SUSSEX AVE.

N.L PURITAN TO McNICHOLS (S.L.)

DEPARTMENT OF PUBLIC WORKS
CITY ENGINEER'S OFFICE
DETROIT, MICH.

SERIES Q-Q

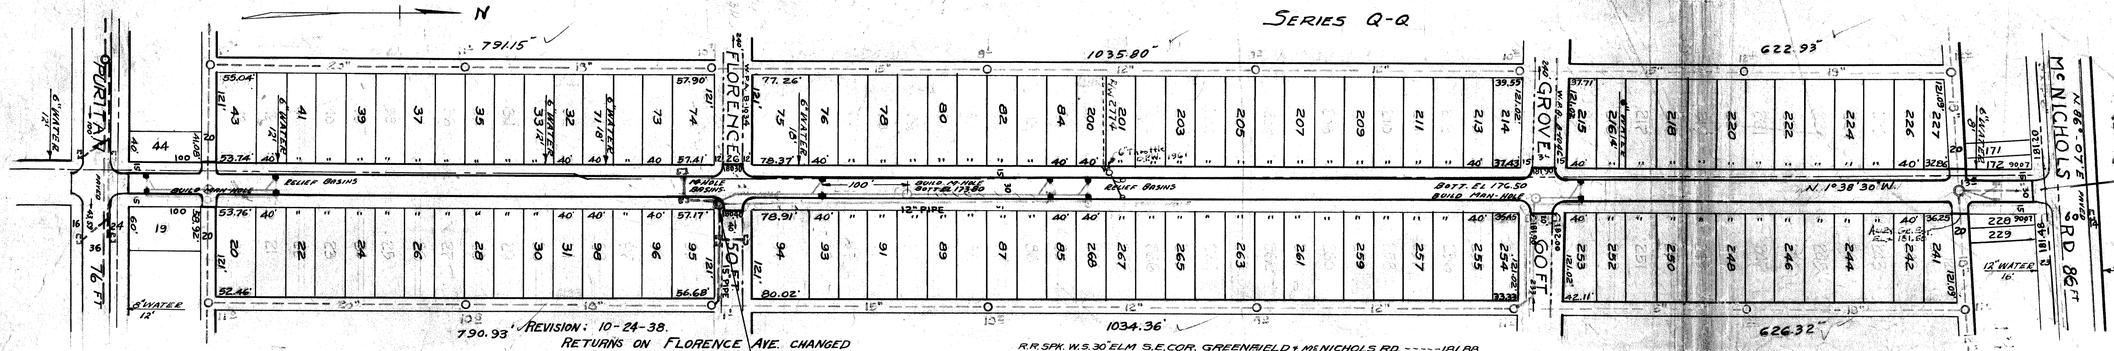
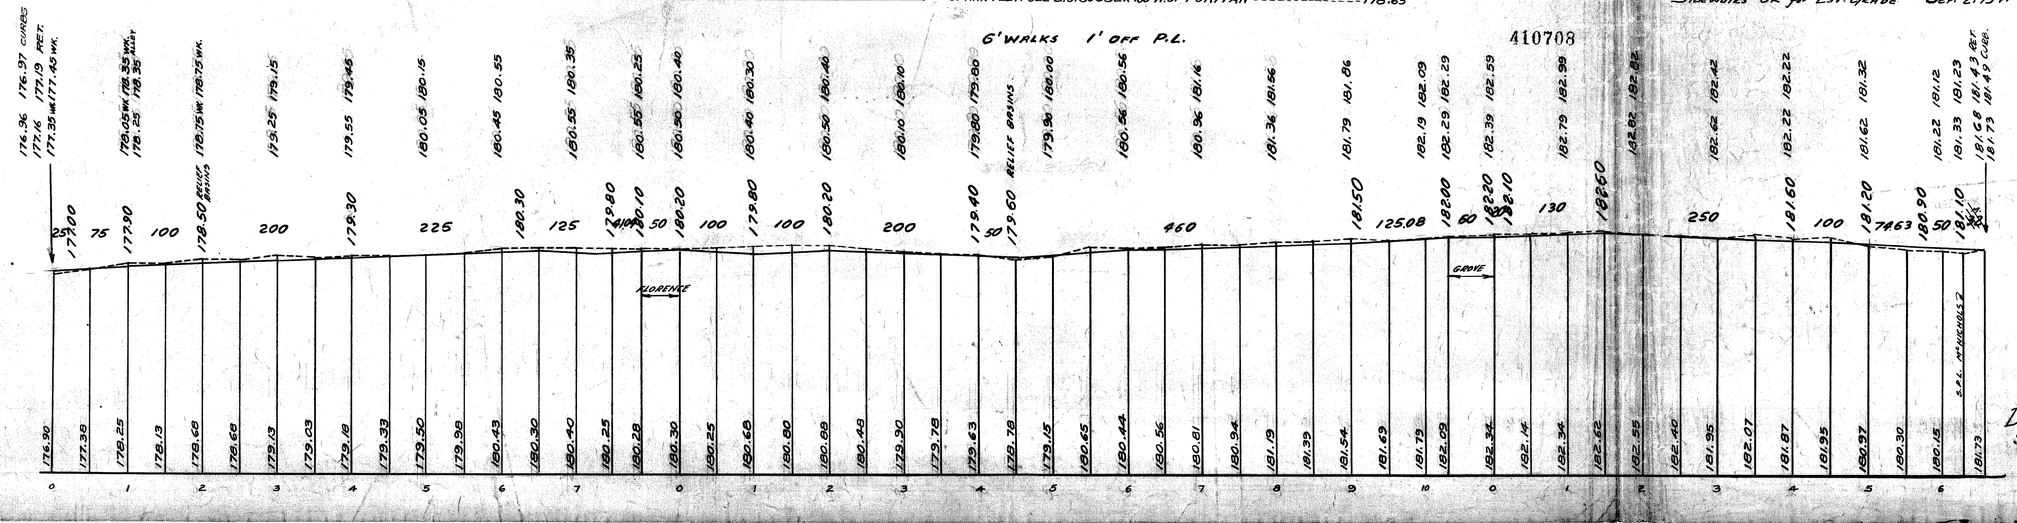
REVISION: 10-24-38.
RETURNS ON FLORENCE AVE. CHANGED FROM 30 FT. TO 26 FT.

CHECK BOTT EL. MAN-HOLE MUST BE NOT LESS THAN 171.20. CHECK SIZE OF PIPE M.H. TO M.H.
